**SITE PLAN REVIEW TECHNICAL ADVISORY COMMITTEE
PORTSMOUTH, NEW HAMPSHIRE**

December 5, 2023

MINUTES

SITE PLAN
SCALE: AS SHOWN
C-102.1

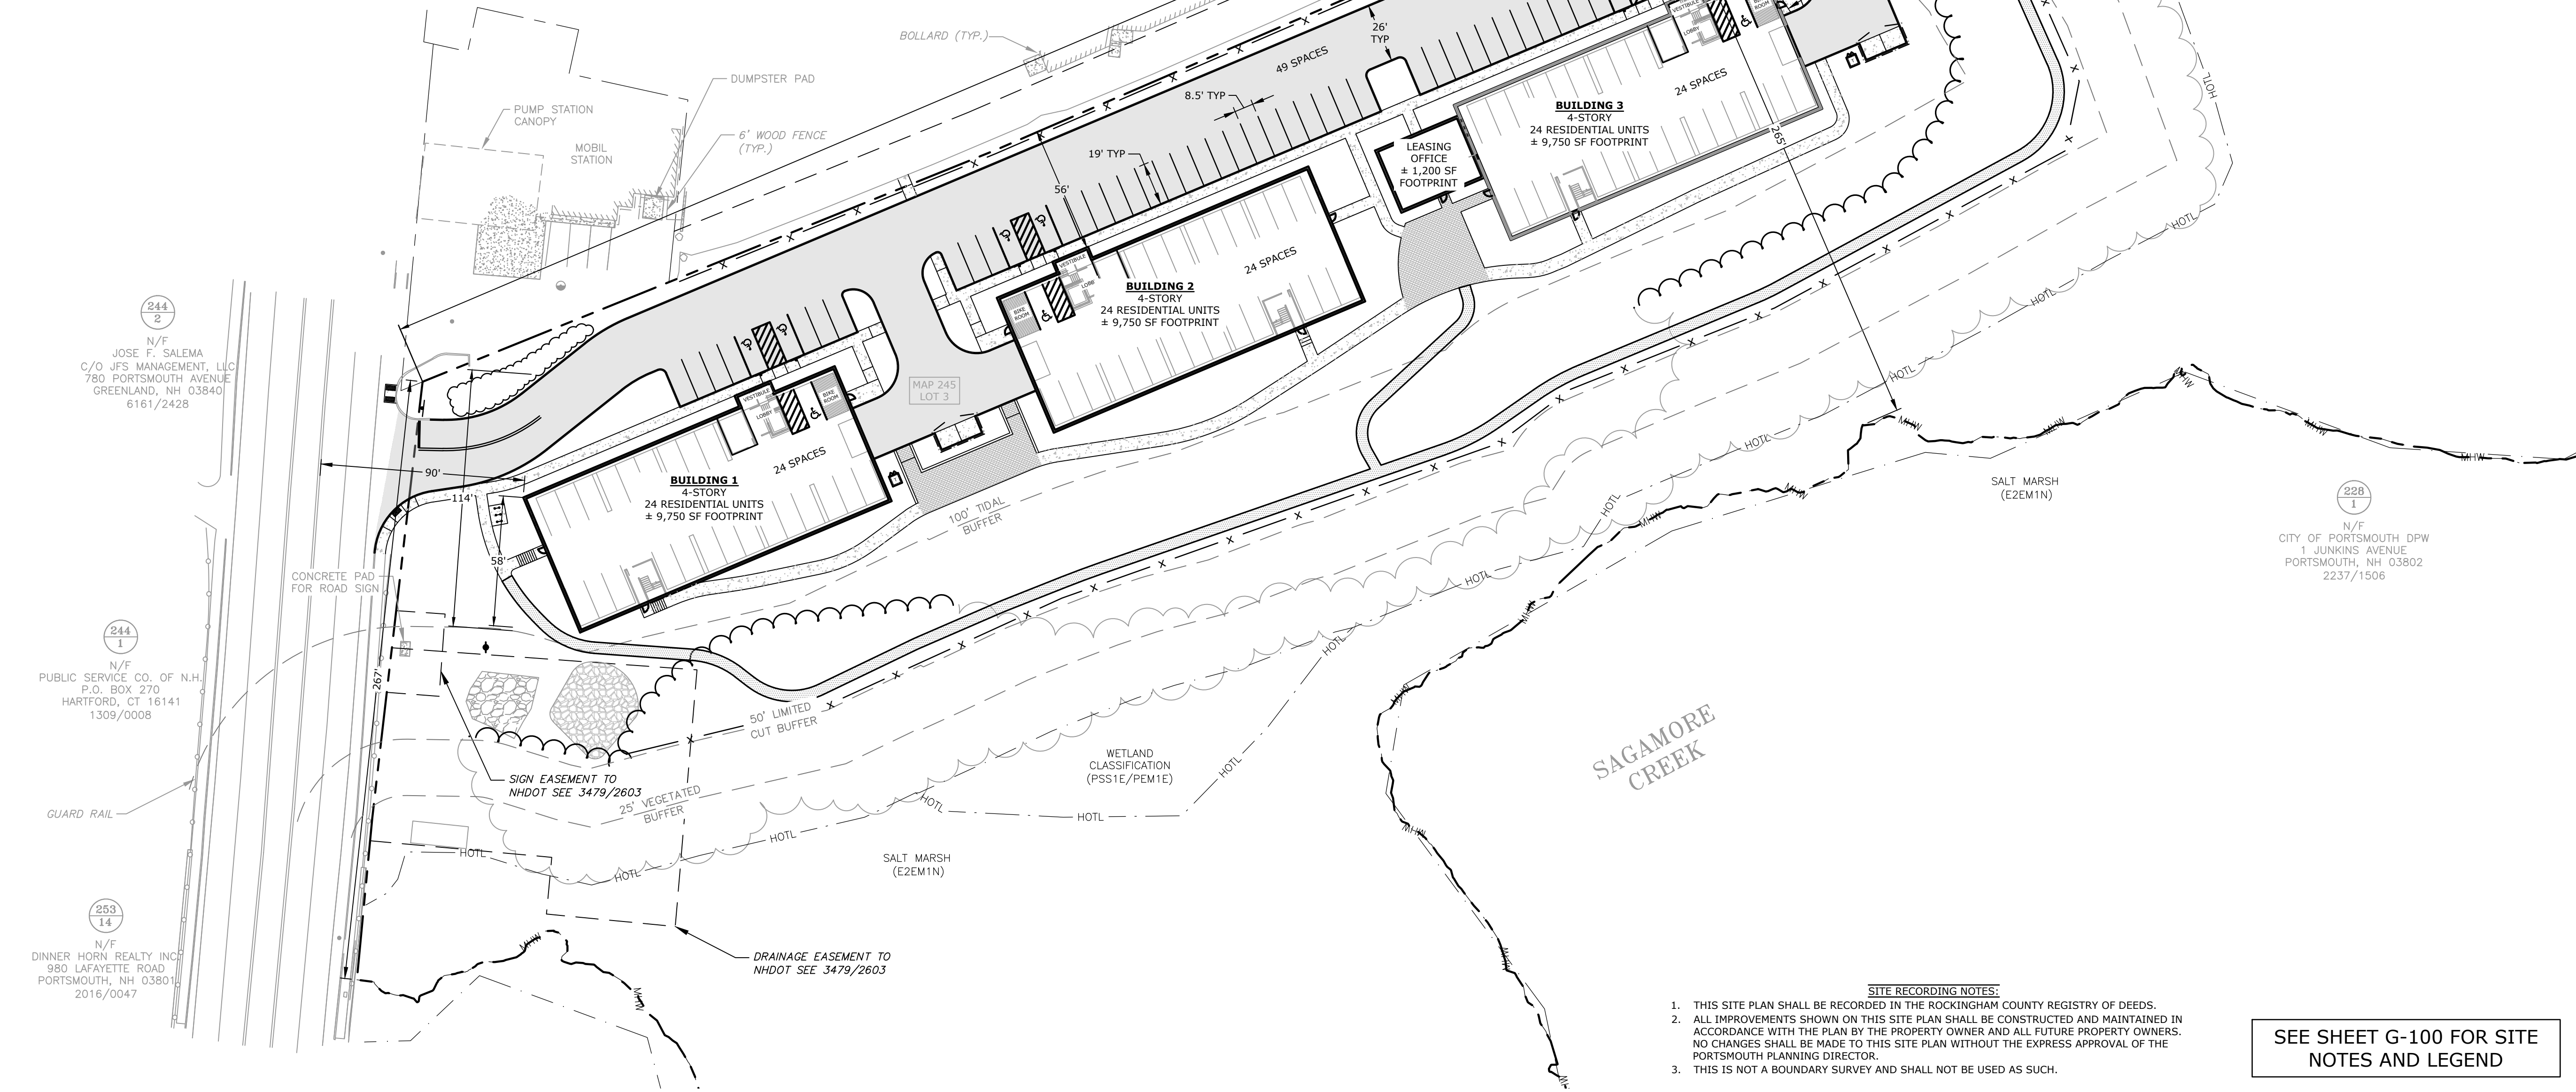
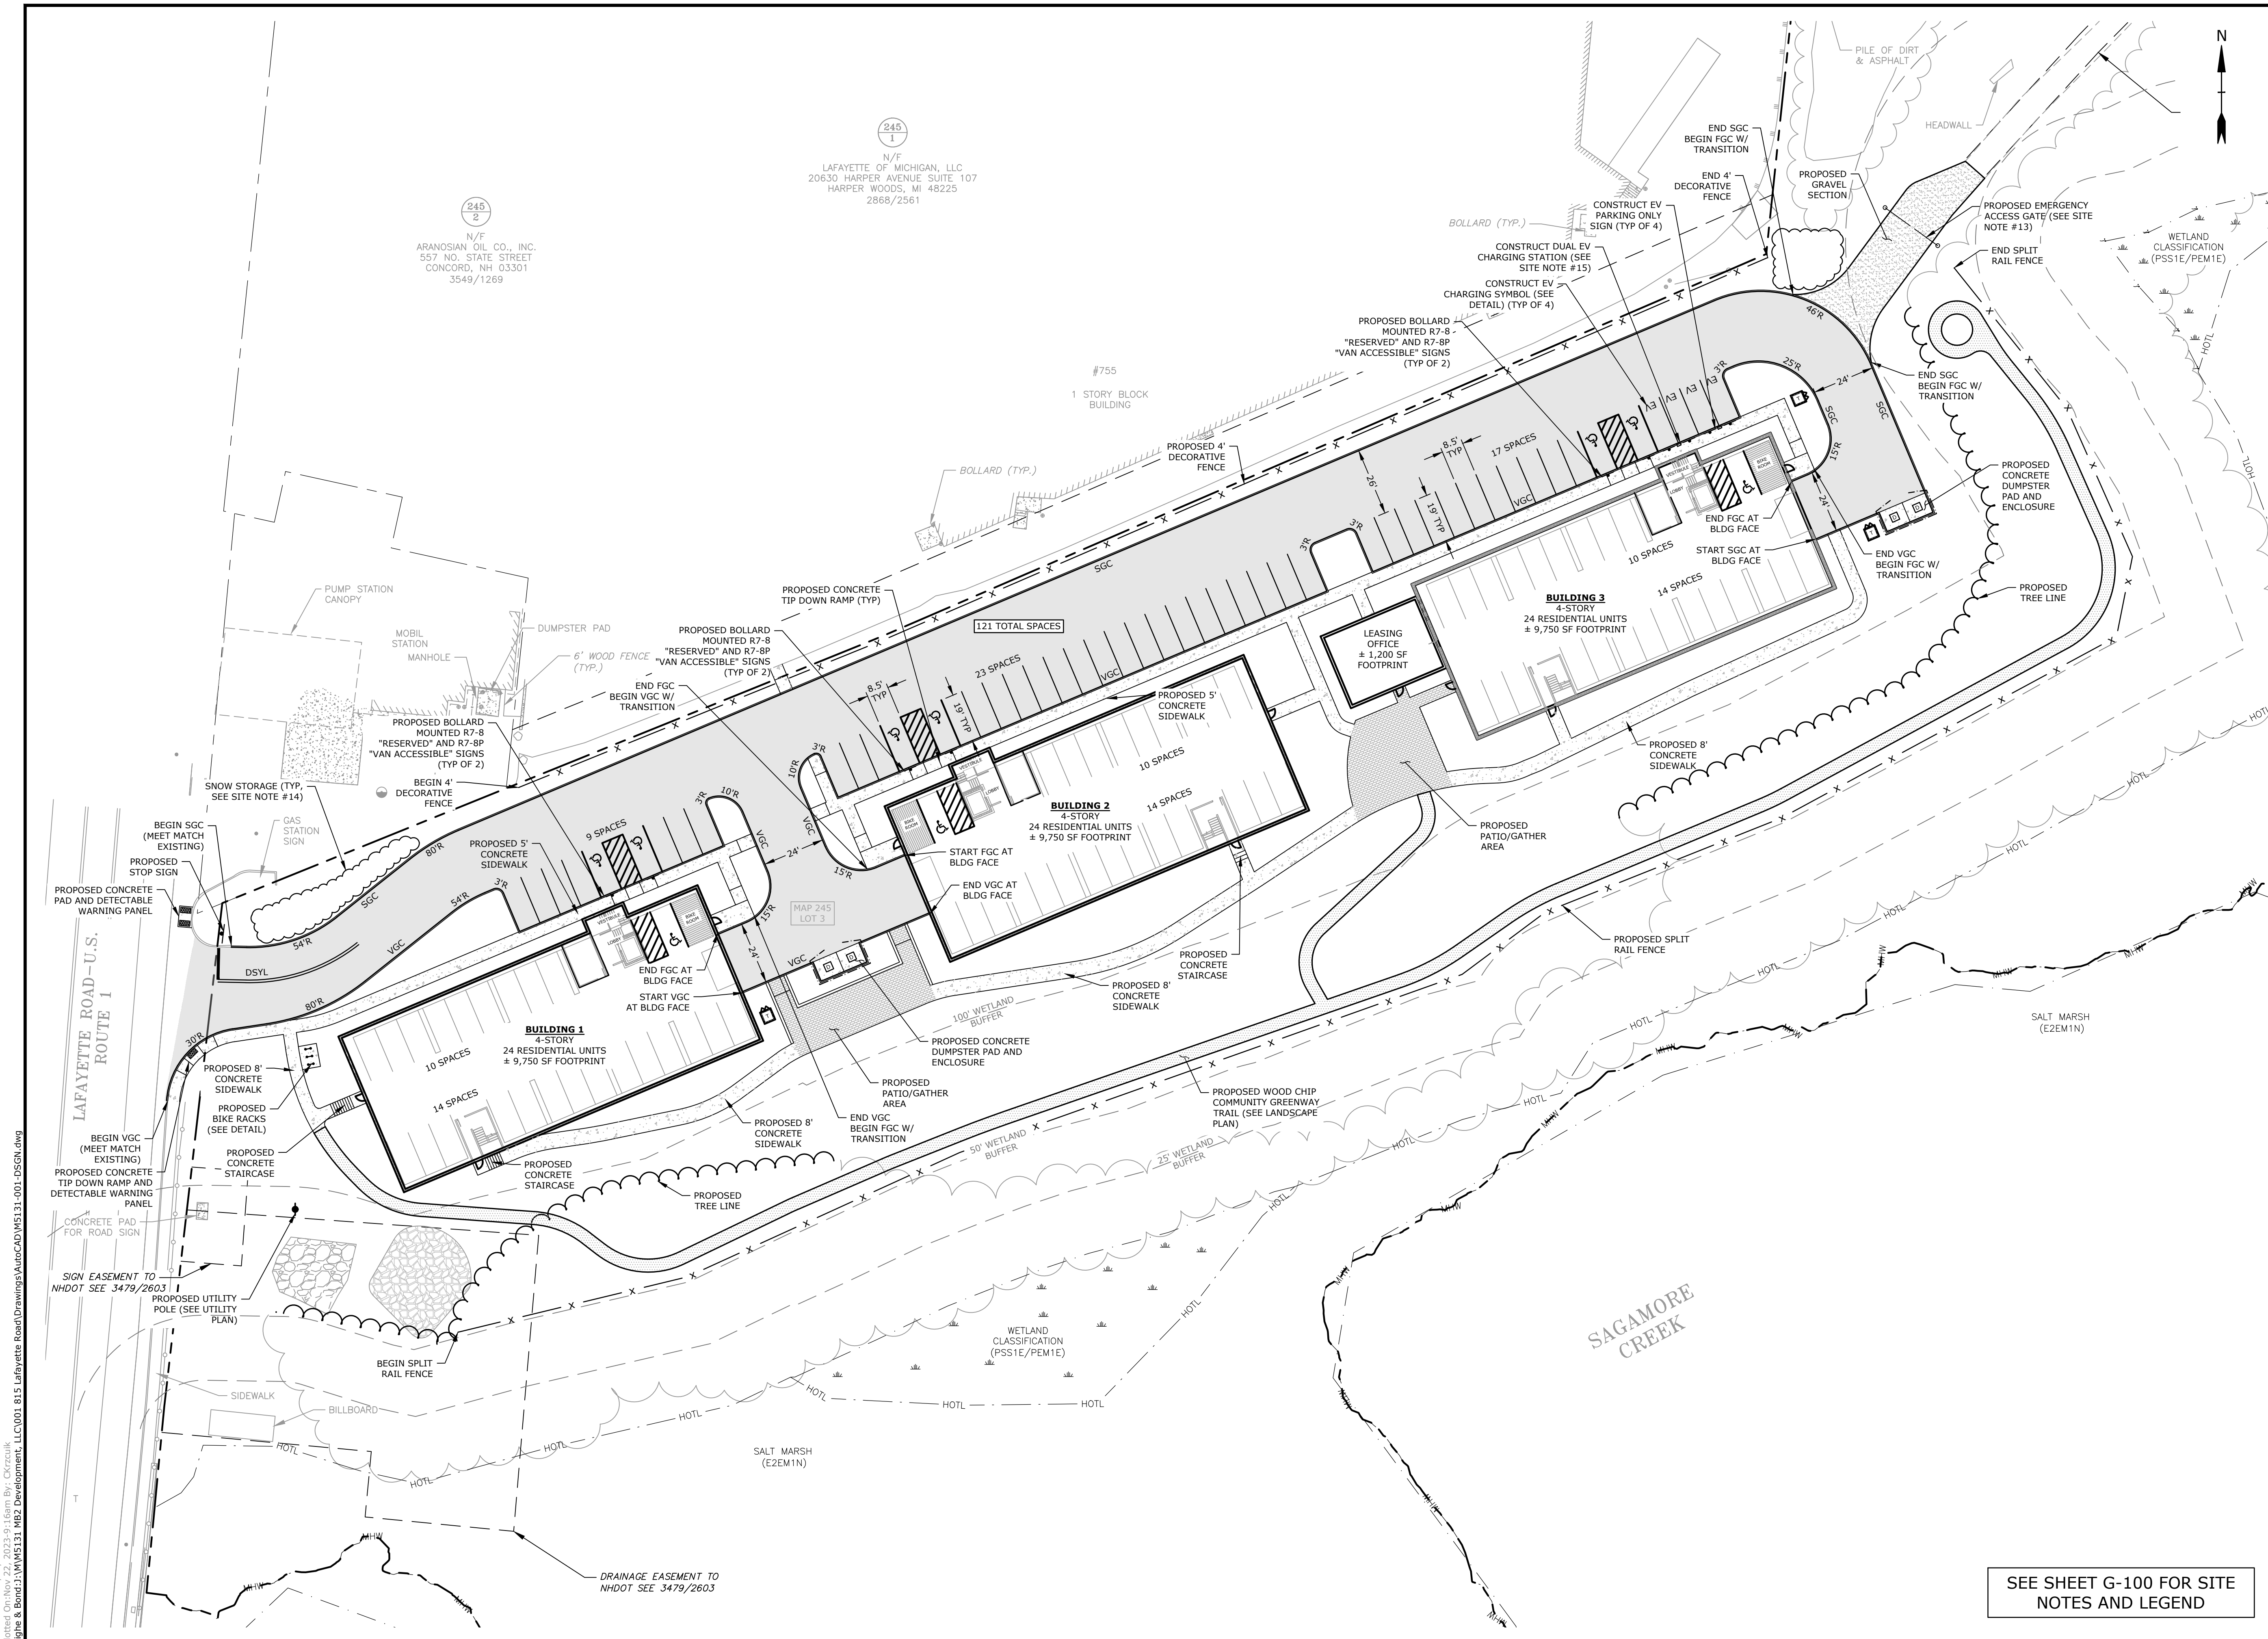
E. Eby noted a mistake on Sheet C-102 where the drive aisle width is labeled as 24' but the plans call it out as 26', Mr. Hansen would correct that. Additionally, on the landscape plan, "shrub" was incorrectly labeled. Mr. Hansen mentioned that this would be fixed as well.

C-201

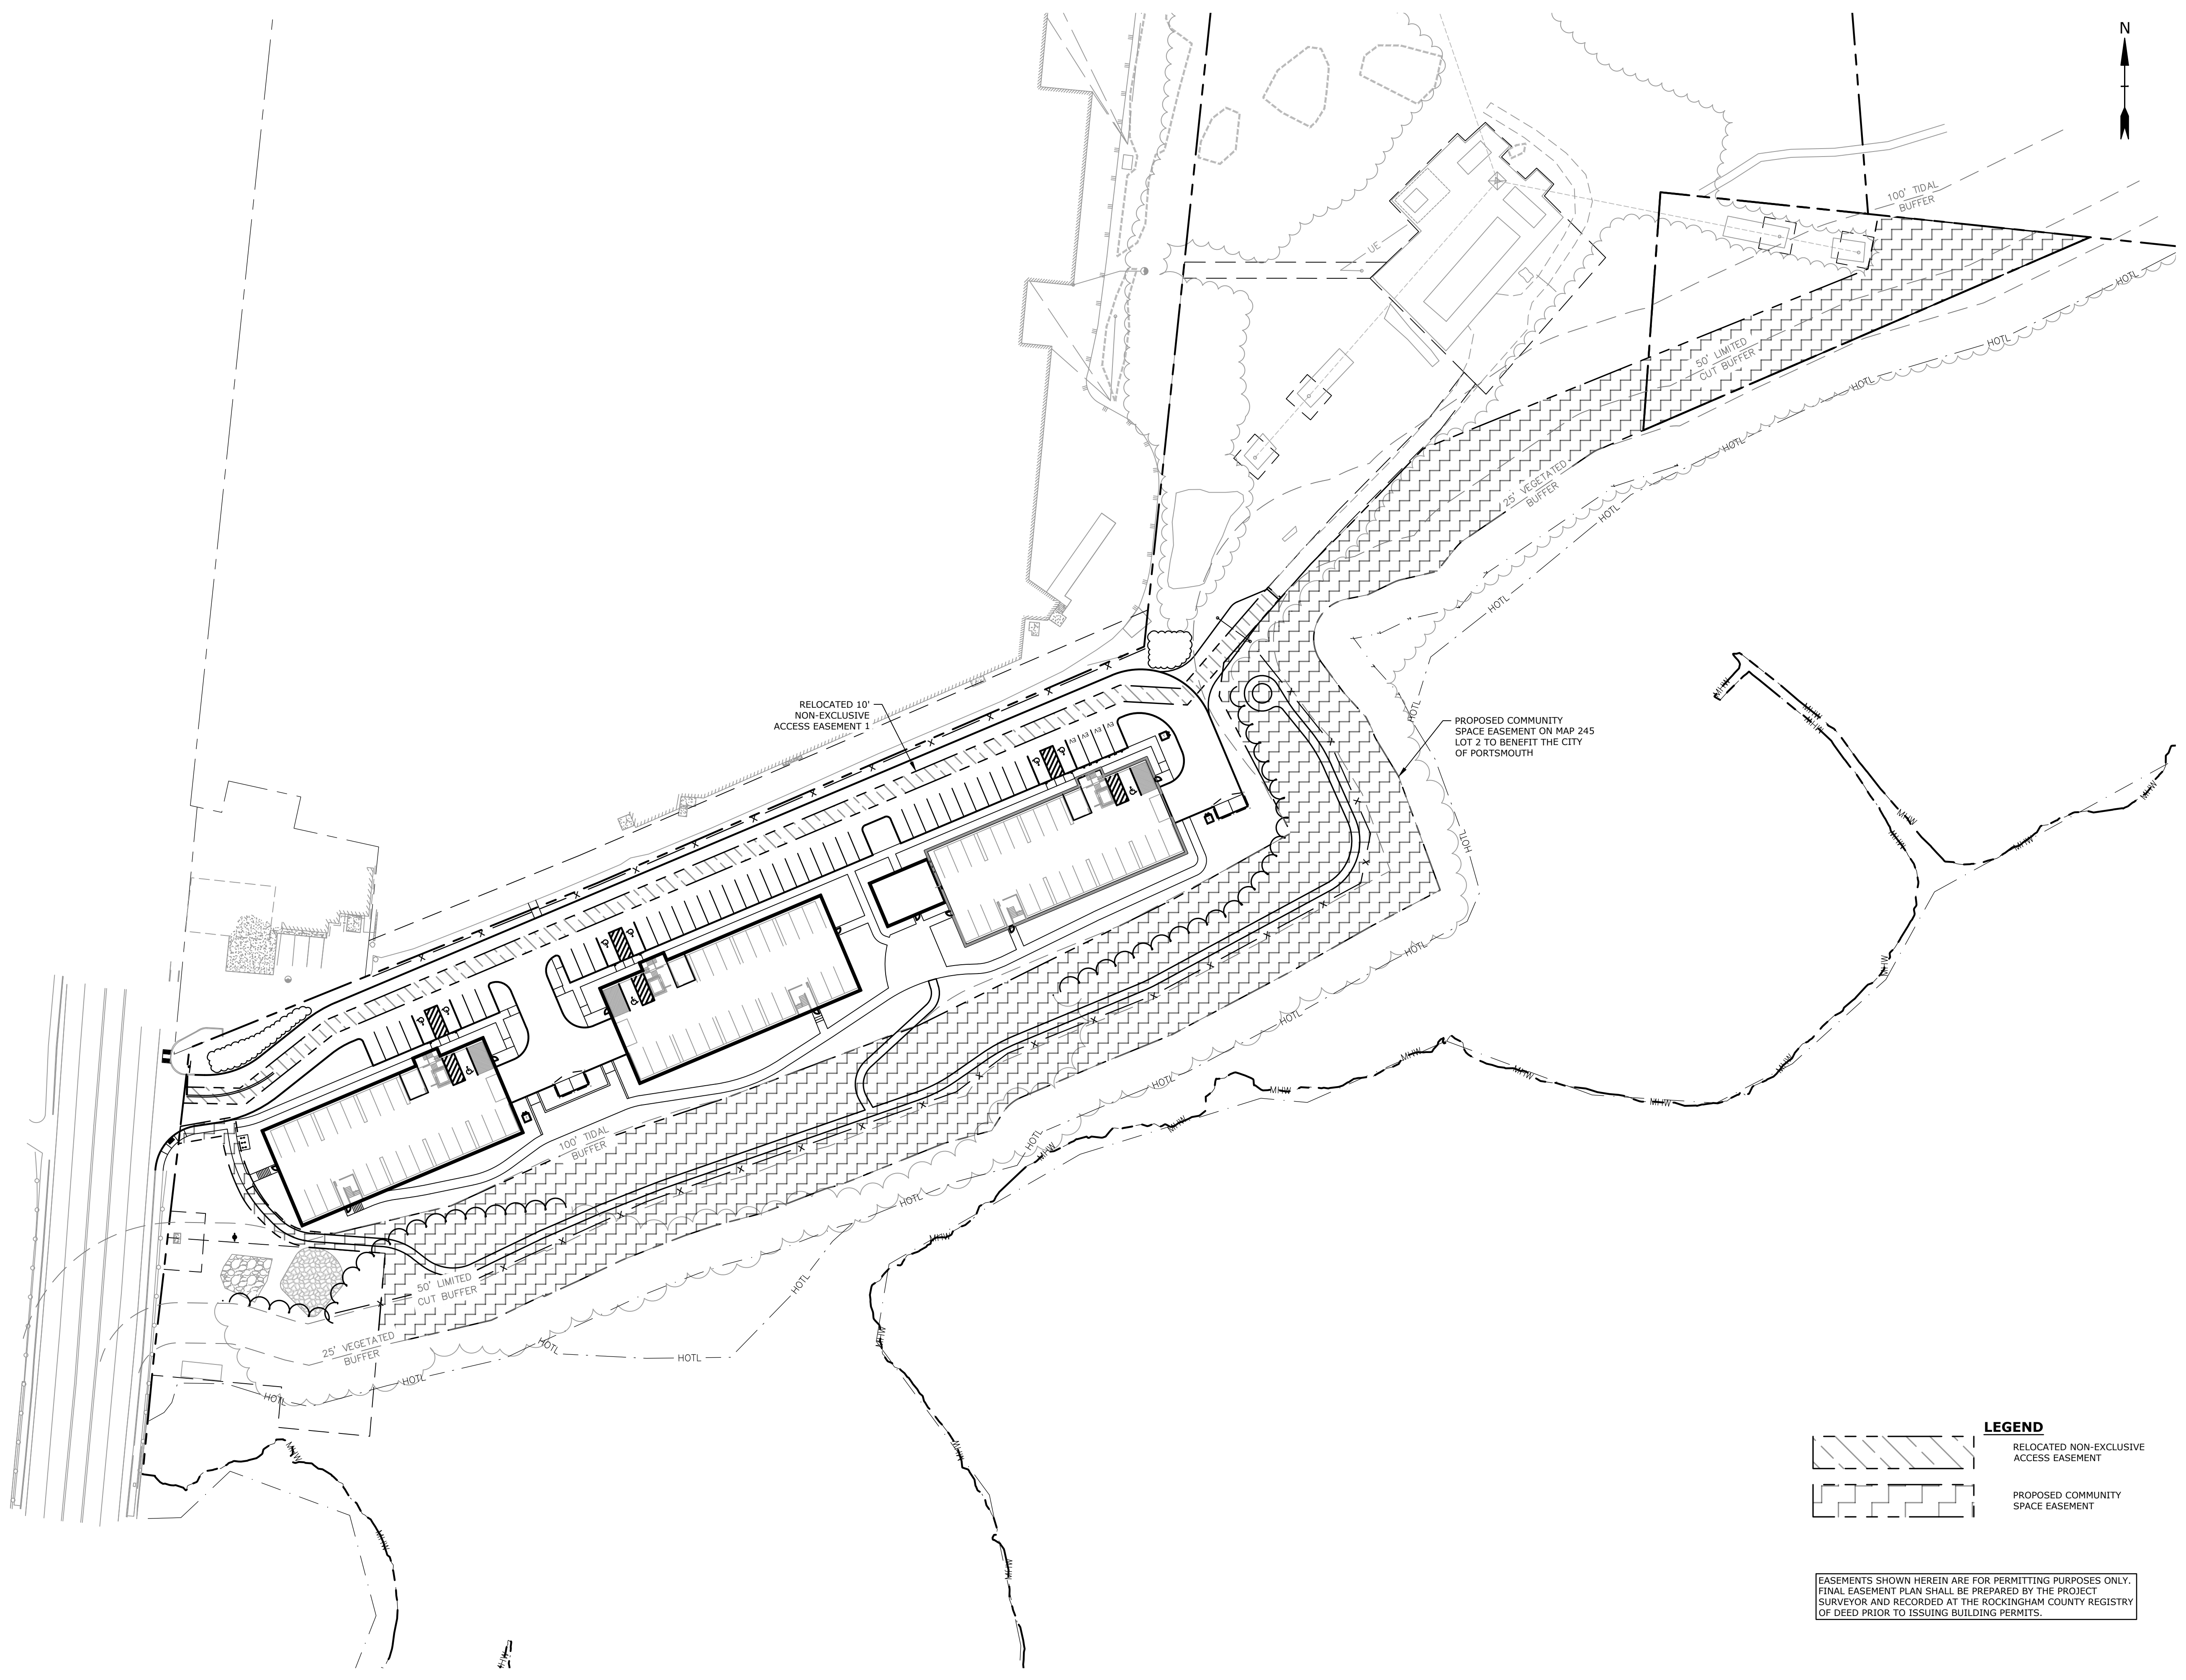
12. *Please provide an easement plan.*

This has already been provided in Sheet C-201.
